SUNDRY NOTICES AND REPORTS ON WELLS
Do not use this form for proposals to drill or to re-enter an abandoned well. Use form 3160-3 (APD) for such proposals.

Gallegos Canyon Unit #512

Gallegos Canyon Unit #512 Proposed P&A

CONDITIONS OF APPROVAL

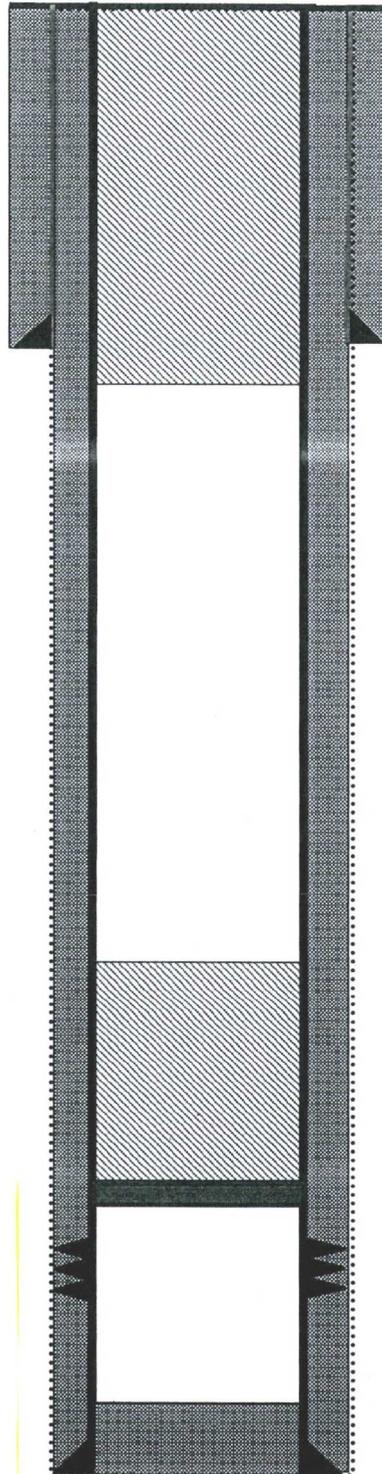
- a) Set Plug #1 (1356 - 1035) ft. to cover the Pictured Cliffs and Fruitland tops. BLM picks top of Fruitland at 1085 ft.
